## HEALTH OFFICER DECISION

Application Type: Building Site Application - New

**Building Site Application (BSA) Residential  
For Onsite Sewage System and Water Supply**

# Onsite Sewage System Specification Sheet For Residential Systems

DATE-	21 MAY 2019
NAME-	PALM
TAX ID-	082501-2-051-2002
STREET-	NW WESTGATE RD
SCALE: 1"=50'	SITE PLAN

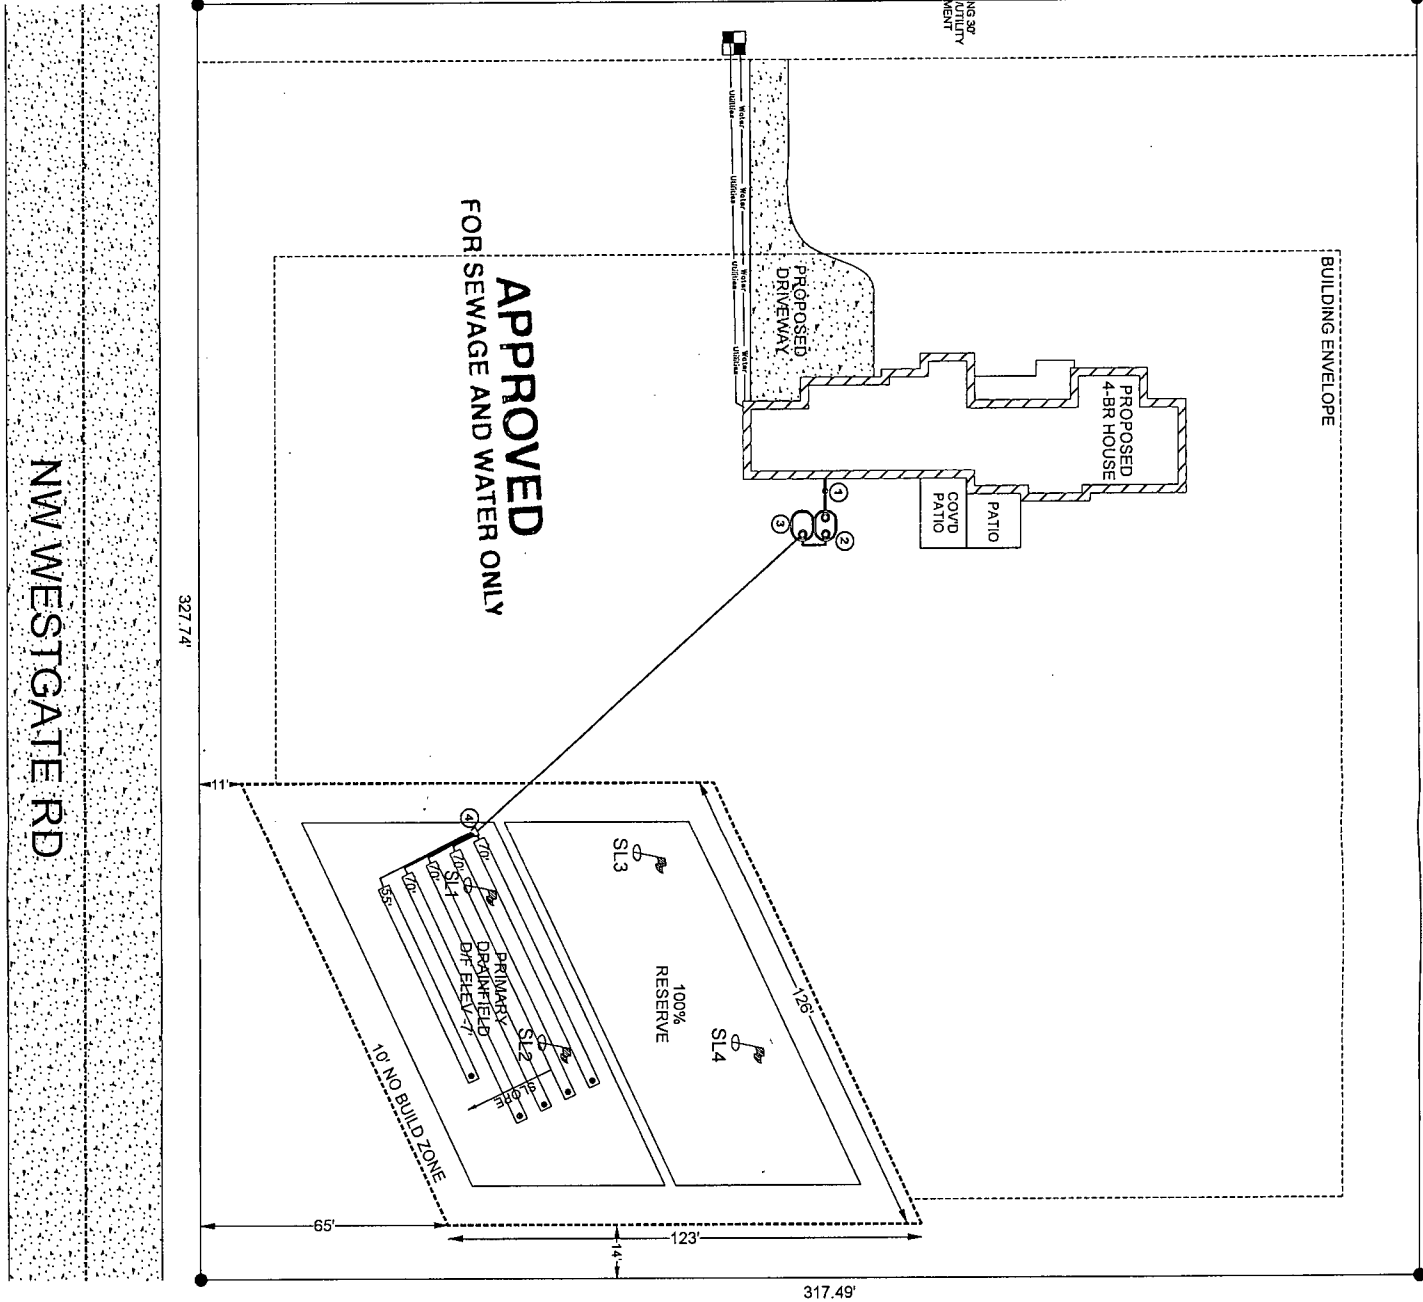
RECEIVED ON	INITIALS	ACTION TAKEN/COMMENTS	ROUTE TO	DATE
05/23/2019	NG	Received OTC - no records.	pb	05/23/2019
5/29/19	RB	Site visit, soil eval - ok, contours - ok, silv H <sub>2</sub> O (public) & water		
6/11/19	RB	Review: 4 bed, lot size - ok, H <sub>2</sub> O - public (silv. water), dispersal/french drains - ok, tankage - ok, step plan - ok, spec sheet - ok & water		
		OSS approved, DW - no wells within 100' - needs BWAL - ok to process to BR pending BWAL	RB	6/11/19
6/11/19	BA	Mailed checklist. Filed in BR pending under "PALM"		
7.2.19	DLG	BWAL ok. Approved. OK to process	BR	7.2.19
7.3.19	BA	(P)	SCAN	7.3.19
